# Work Order ID 89116

Item Name: Crosstube Turning Detail

<b>DART AEROSPACE LTD</b>	<b>Work Order:</b>	89116
<b>Description:</b> Crosstube Assembly (205/212/412 Low Fwd)	<b>Part Number:</b>	D212-664-147
<b>Inspection Dwg:</b> D212-664-147 <b>Rev:</b> B		<b>Page 1 of 2</b>

DRAWING NO. D212-664-147	TITLE CROSSTUBE ASS'Y (205 LOW FWD)	REV. B	<b>DART AEROSPACE LTD ENGINEERING ORDER</b>		D.E.O. NO. D212-664-147-B-1	SHEET NO. SHEET 1 OF 1	SCALE NTS
DRAWN <i>q</i>	CHECKED <i>ASS</i>	MFG. APPR. <i>VB</i>	APPROVED <i>WJ</i>		DE APPR. <i>WJ</i>		
DATE 11.07.15	DATE 11.07.20	DATE 11.07.21	DATE 11/07/21		DATE 11.07.21

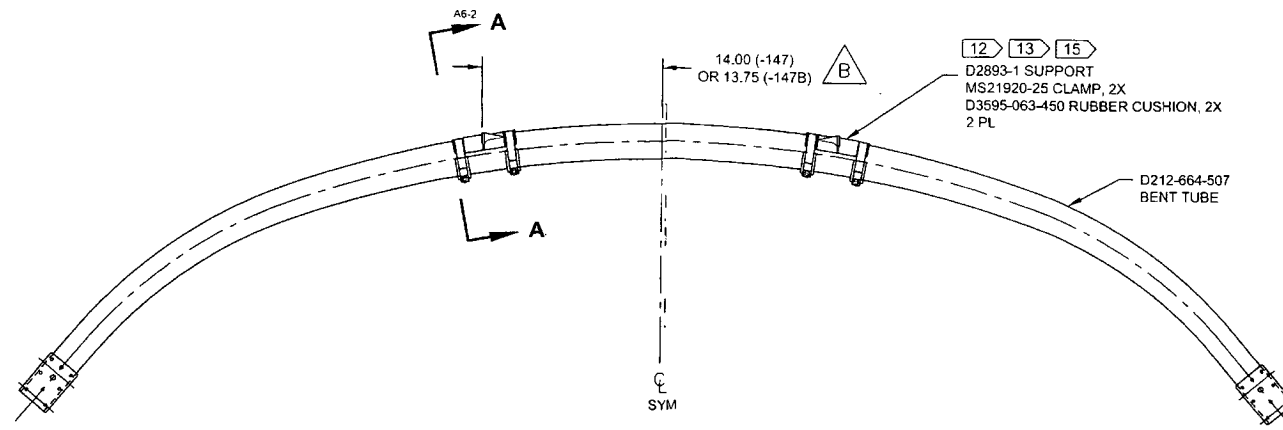
REPLACE MAGNOBOND WITH PROSEAL.

NOTE 12 & 15, SHEET 1 IS AMENDED AS FOLLOWS:

Item	Qty -147	Qty -147B	Part Number	Description
9	A/R	A/R	PROSEAL 890 B-2	SEALANT, AMS-S-8802 CLASS B-2

- 12) TO INSTALL D2893-1 SUPPORT: ABRABE MATING SURFACE OF SUPPORT AND CROSSTUBE WITH 180-GRIT SANDPAPER AND REMOVE RESIDUE WITH MEK (OR EQUIVALENT). APPLY A 0.04" TO 0.07" THICK LAYER OF PROSEAL 890 CLASS B-2 (OR AMS-S-8802 CLASS B-2) SEALANT TO MATING SURFACE OF SUPPORT.
- 15) TORQUE CLAMPS 80 TO 100 IN-LB. ENSURE AT LEAST 1.5 THREADS SHOWING IN SAFETY AND THAT NUT HAS NOT BOTTOMED-OUT AFTER TORQUING. **PRIOR TO PACKAGING, RE-CHECK TORQUE ON CLAMPS AFTER PROSEAL 890 SEALANT HAS CURED FOR 72 HOURS.**
